# Delaware River Basin Flood Analysis Model Independent External Peer Review Report

Prepared for:  
Federal Emergency Management Agency, Region III  
Delaware River Basin Commission

January 6, 2012

Figure 5.1 Example Showing how Local Runoff at Harvard was Estimated for the 2005 Event

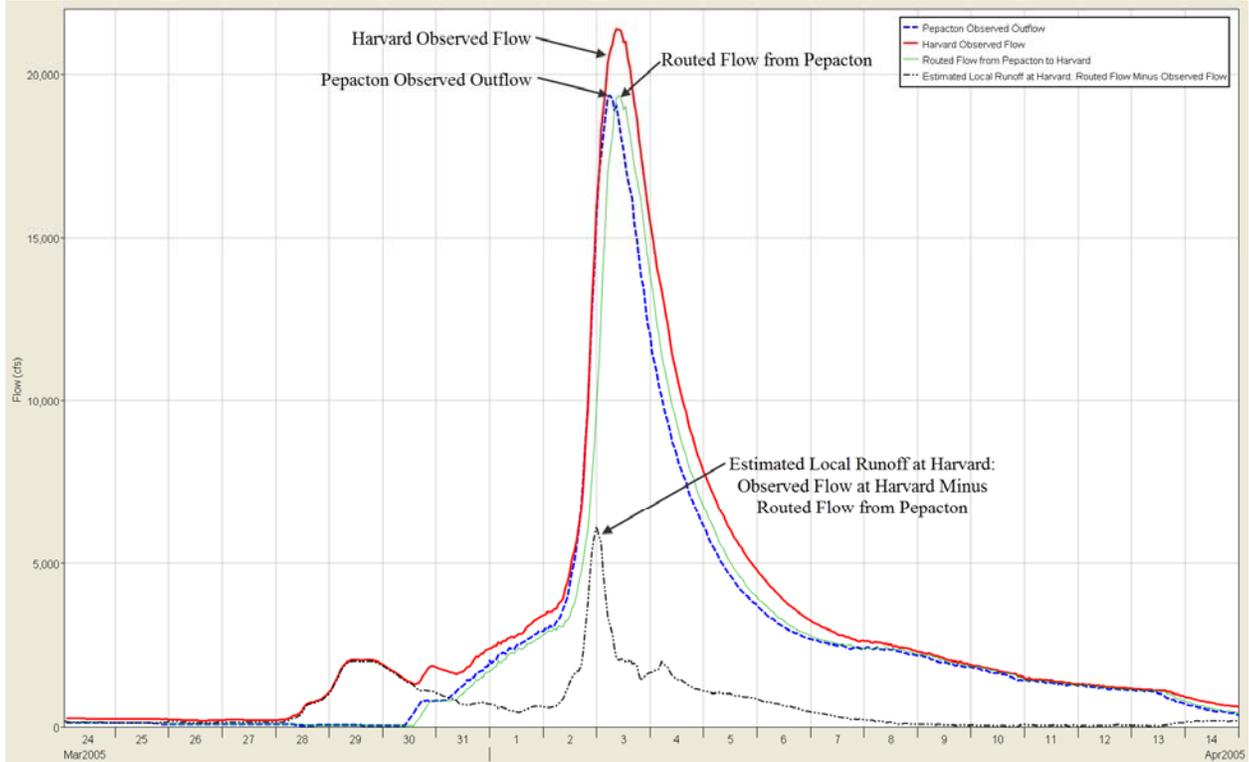
28. Comment - Model. For the *FC-GageQ* alternative, the model uses local inflows calculated from observed data at gaging stations. The supporting data did not include any documentation that describes how this was done. We recommend that the calculations and documentation of the local inflows be provided and checked as these local inflows are important input to the model.

Back-Check Comment – The changes made to the report are very useful. However, one of the labels in Figure 5.1 in the report is not correct. As shown in Figure 5.1 in HEC’s response document, the estimated local runoff at Harvard should be equal to observed flow minus routed flow.

The following paragraph and figure were added to the second paragraph in Section 5.1 to expand on the development of the local runoff hydrographs. The procedure followed is straight forward and uses observed releases from reservoirs, observed stream flow at gage locations, and the HEC-ResSim model. This description includes the basic procedure for estimating the local runoff hydrographs and can be followed to recreate the data used in the FC-GageQ alternative. All local runoff hydrographs are included in the LocalRunoff.dss file located within the HEC-ResSim model files, “shared” directory. Finally the report states that it is not intended that the FC-GageQ alternative be used for investigating the response of the reservoir network to alternative flow scenarios. This was the intended application of the inflows developed from the PRMS model (which was the intent of the study). The intended use of the local runoff hydrographs in the FC-GageQ alternative was to assist in the development of operational rules for reservoirs within the HEC-ResSim model. The goal of their development was to insure that when combined and routed they recreated observed flow at gaged locations.

A simplified version of the HEC-ResSim model was used to develop the local runoff hydrographs. First, all reservoirs were removed from the model and observed releases from the reservoirs were used as the boundary condition for headwater reaches. Then, these observed releases were routed downstream to the next junction with observed flow. The local runoff hydrograph was then computed by subtracting the routed flow from the observed flow. An example is shown in Figure 5.1. The observed releases from

Pepacton Reservoir were routed downstream to Harvard. Then the local runoff hydrograph was computed by subtracting the routed flow from the measured flow at Harvard.

**Figure 11. Main intake discharge capacity curve in the model.**

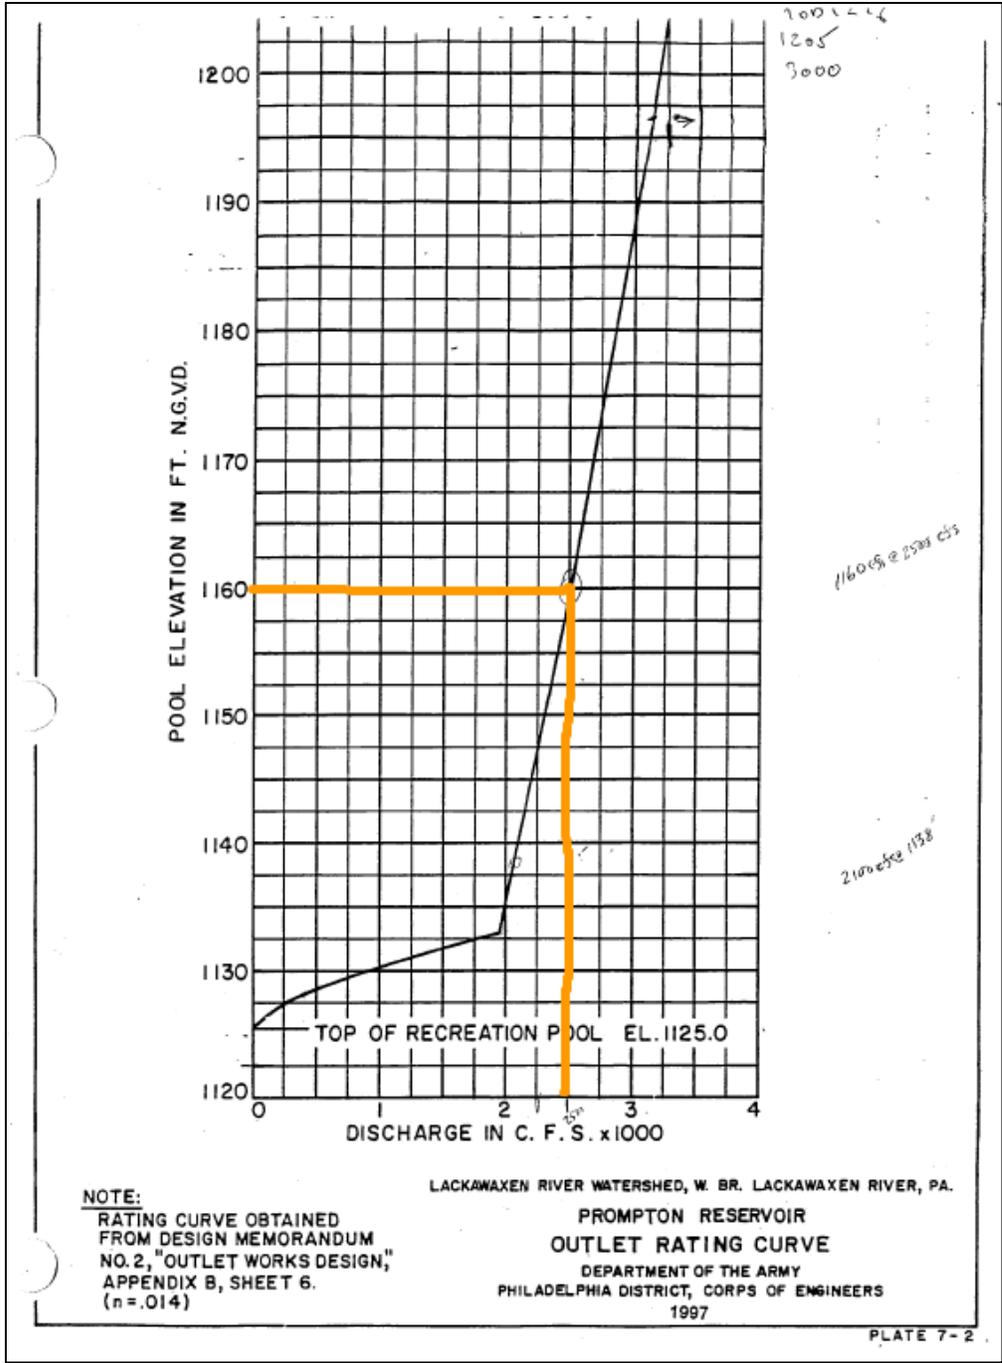
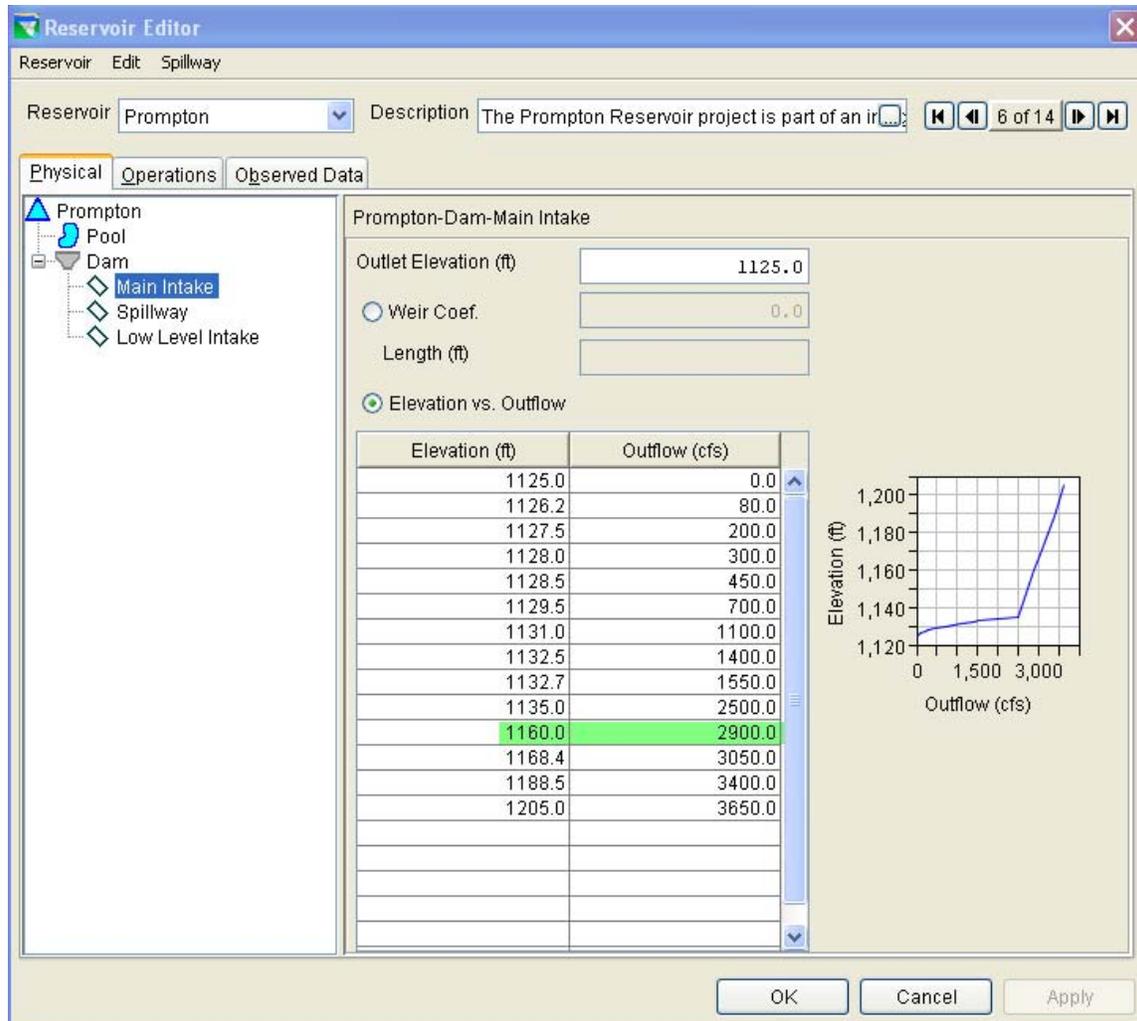
29. Comment - Model. Prompton. The discharge capacity curve for the main intake entered in the model does not match the chart in the water control manual. As shown in Figure 10 and Figure 11, at pool elevation 1,160 ft, the discharge from the chart is 2,500 cfs. In the model, the discharge at this elevation is 2,900 cfs.

Comment Response – Yes, it is true that the rating for the “main intake” outlet at Prompton does not exactly match the design capacity used in the Oasis model and documented in the water control manual. Since matching observed flows was a primary objective of the DRBC representatives, the rating of the main intake was adjusted to allow releases and associated pool elevations to better reflect observed conditions. This is best illustrated in the 2004 event – the observed data for this event only peaked at approximately 1138’ with a maximum release of approximately 2600 cfs; with the original rating, the pool would have had to exceed 1160’ to produce a release of 2600 cfs .

A number of factors can influence differences between design capacity and current capacity including post-design modifications resulting in a different, as-built, configuration, later modifications made to the structure after original construction, and natural “wear and tear” of the structure. A separate effort utilizing an extended period of observed data, appropriate statistical analysis methods, and all historic records of construction and alterations that may have been made to the structure would need to be performed to produce a more accurate rating of the current outlet capacity of the structure.

**Figure 13. Prompton Reservoir Elevation-Storage-Area table in HEC-ResSim model.**

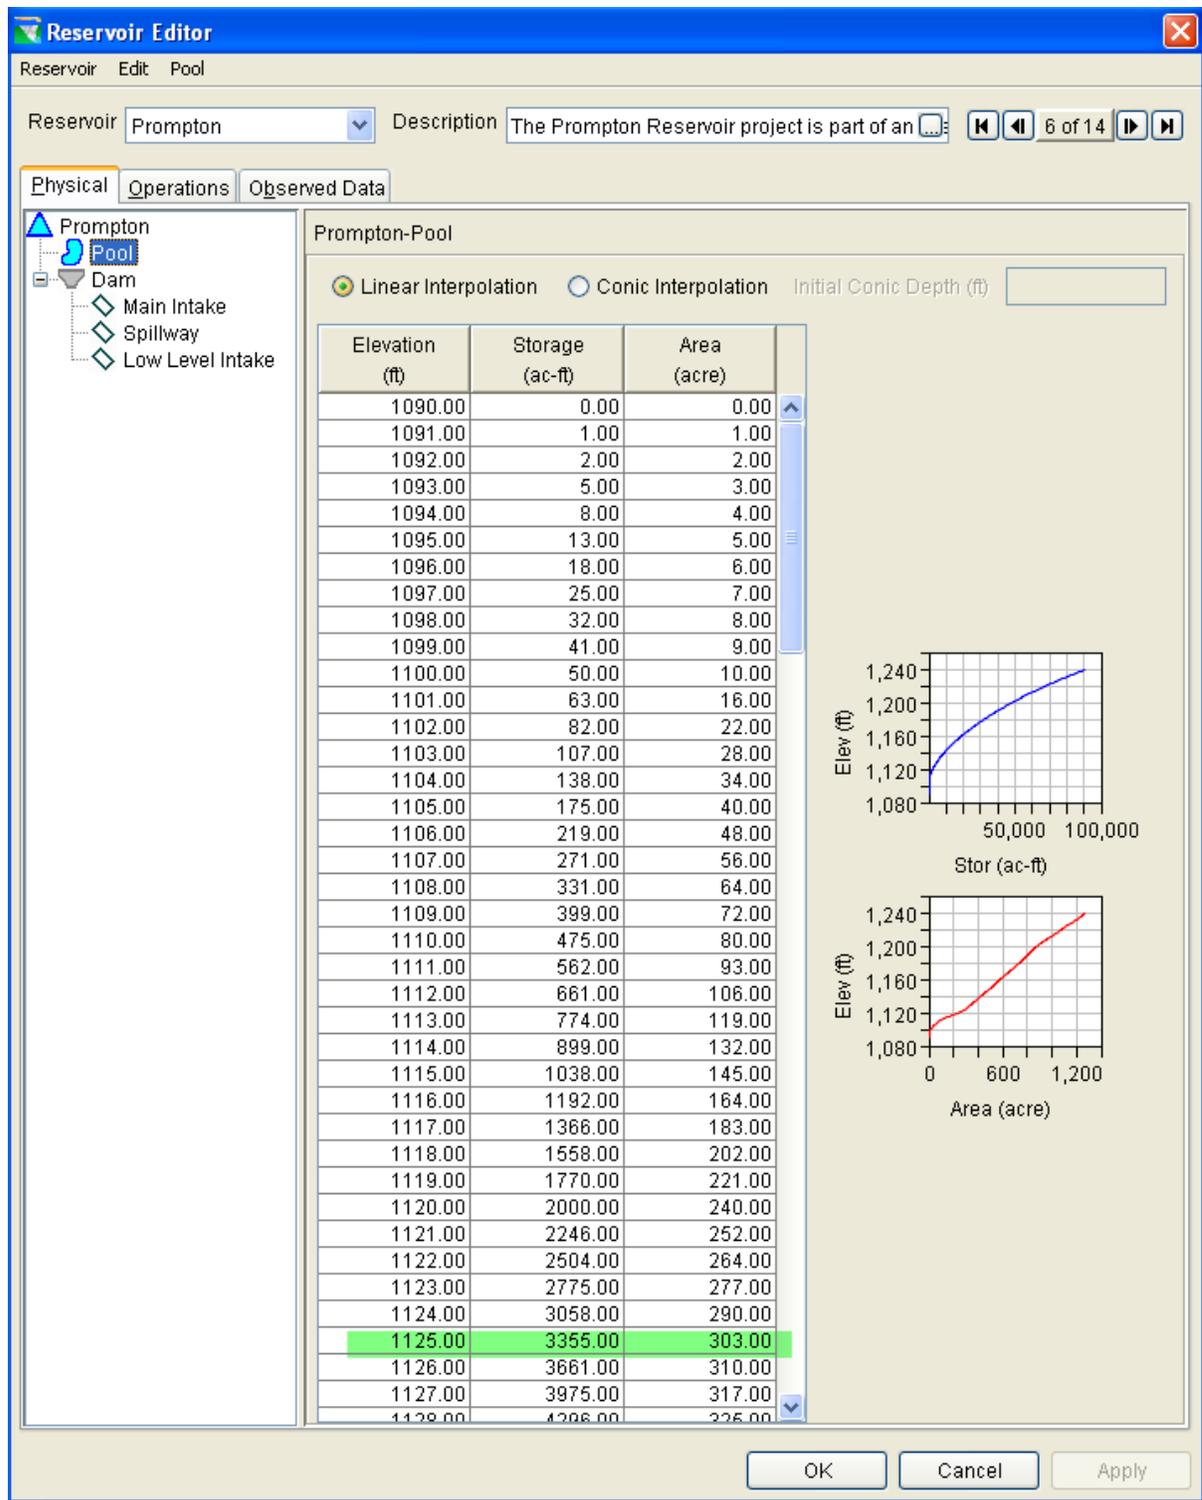
30. Comment - Model. Prompton. The elevation-storage-area data in the model were apparently taken from the water control manual. As shown in Figure 12 and Figure 13, the data are different from those used in the OASIS model. Which set of the data is more representative of the current reservoir condition?

Comment Response - In general, where data was available from the owners of a given project, that data was applied in the model. However, where data was otherwise unavailable, the OASIS model data was used. HEC has no knowledge of the source of the data used in

the OASIS model so cannot comment on which is the more accurate.

**Figure 17. Lake Wallenpaupack water elevation information sheet.**

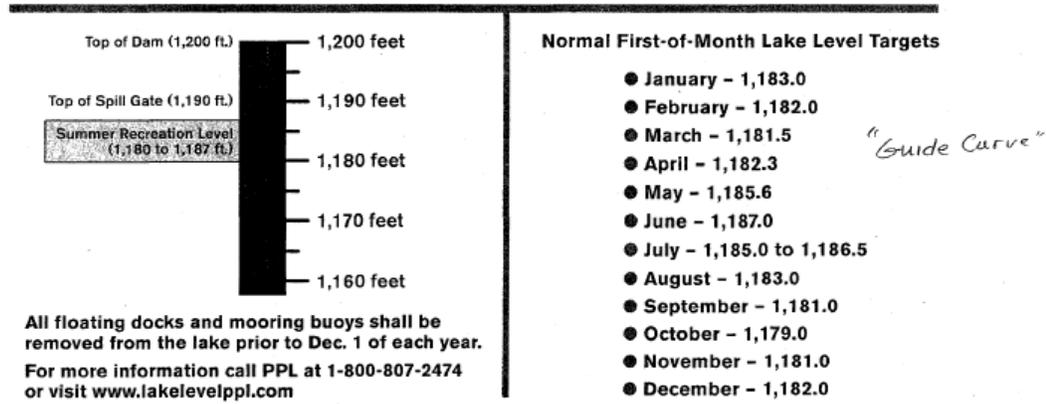
32. Comment - Model. Lake Wallenpaupack. The seasonal guide curve in the model (Figure 16) is the same for the 2004, 2005, 2006 flood events. The guide curve might be taken from Table 2 in DRBC Resolution No. 2002-33 (Page 4). However, this table might have been superseded by a more recent table included in both the Lake Wallenpaupack Emergency Action Plan, December 2007 Revision (Page G-23) and the Lake Wallenpaupack Water Elevation Information sheet (Figure 17).

**Figure 18. TorontoFlashboards state variable.**

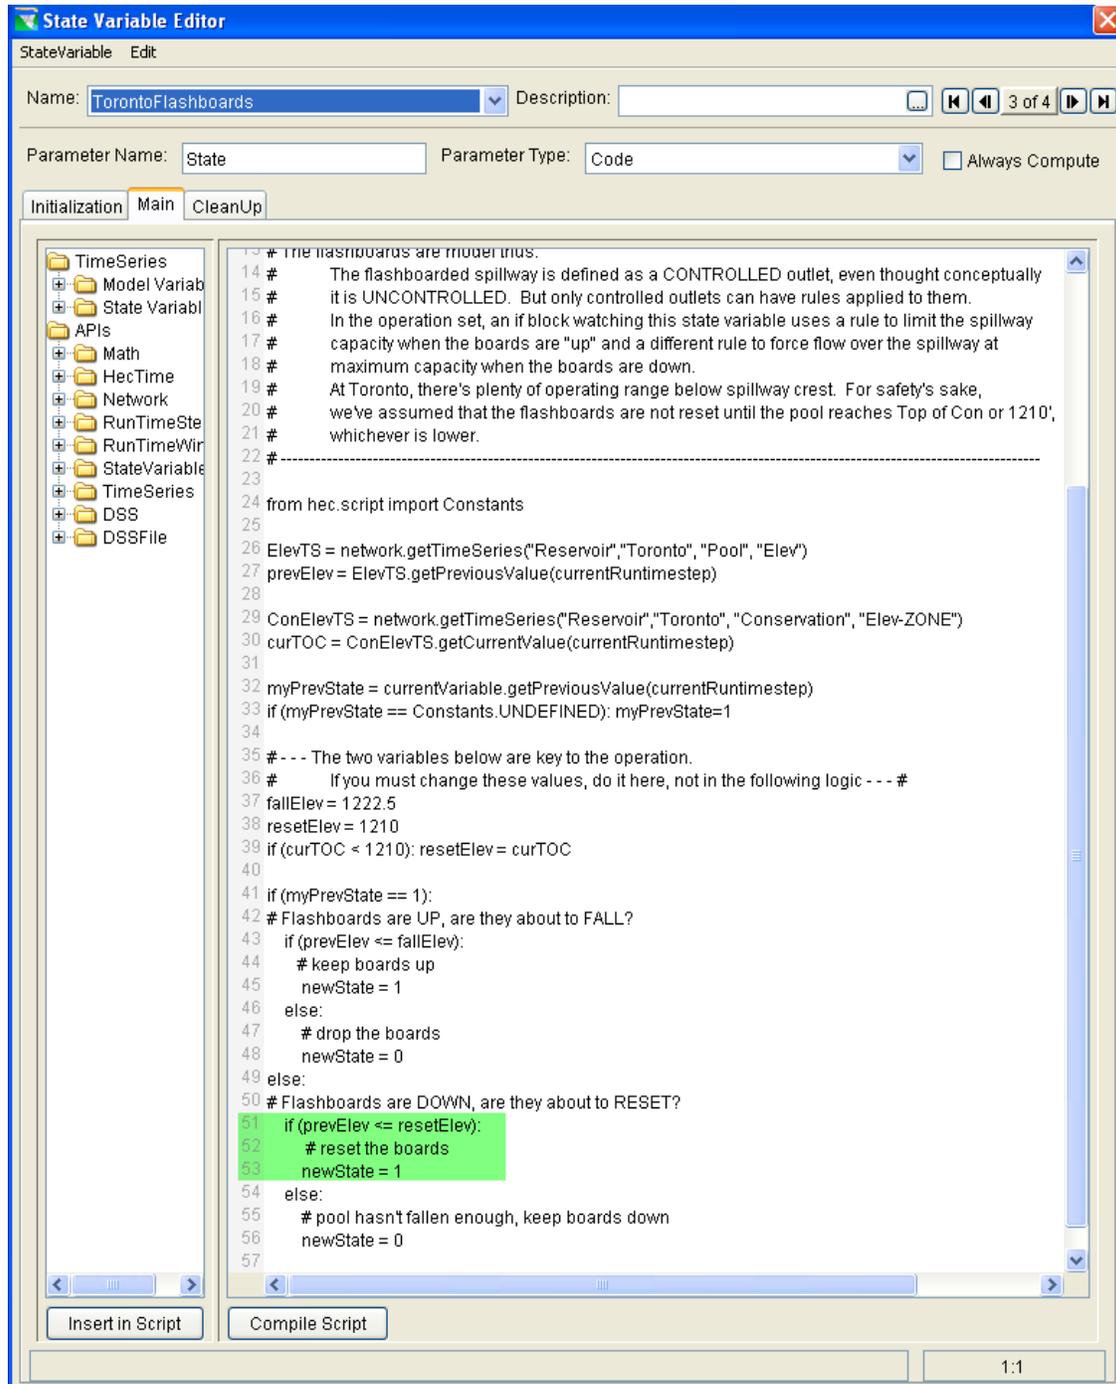
33. Comment - Model. Toronto. Figure 18 is the state variable script used to determine whether the flashboards are up or down by comparing the pool elevation at the previous hour to two

triggers: an elevation above which the flashboards fall, labeled as *fallElev*, and another elevation below which the flashboards are reset, labeled as *resetElev*. Rows 51 through 53 in the script indicate that when the pool elevation is below *resetElev*, the flashboards will be reset in one time step, which is one hour. This may not realistically represent the time that is typically needed to reset the flashboards.

Comment Response - Agreed. In fact, both the fall and reset elevations reflect a huge

A description of the scripts as well a copy of one of the scripts was added to section 4.3.2.4 and included here:

**Figure 19. SwingingBridge\_Flashboards state variable.**

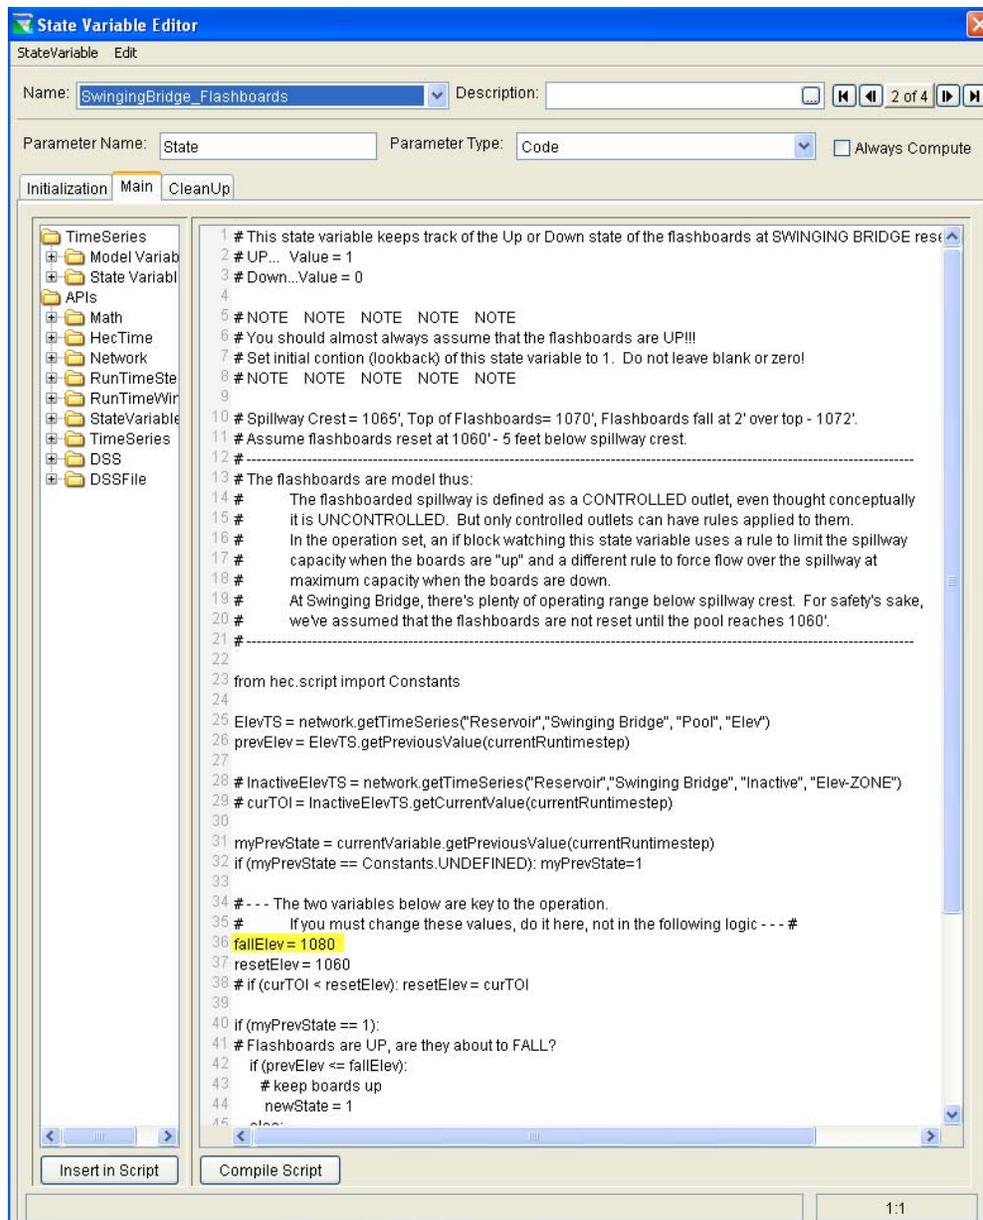
34. Comment - Model. Swinging Bridge. Figure 19 is a similar state variable script used to determine whether the flashboards installed on Swinging Bridge Dam are up or down. As Row 36 indicates, the elevation above which the flashboards fall (*fallElev*) is currently set to a very high value (1,080 ft). The design elevation is 1,072 feet. This is a necessary modeling technique to simulate what had happened with the flashboards during the three events. In the 2005 event, the flashboards failed to fall as designed. Accordingly, setting *fallElev* to a very high elevation would keep the flashboards up. We suggest describing this modeling approach in the report and adding a warning note both in the model and in the report that this triggering elevation needs to be changed to the design elevation of 1,072 ft if the model is used for future flood events and if the flashboards have been rebuilt.

Comment Response - Agreed. The observed conditions were described in the report, but the alterations to the script were not. The following line was added to the second paragraph of section 4.3.2.6 of the report to complete the explanation:
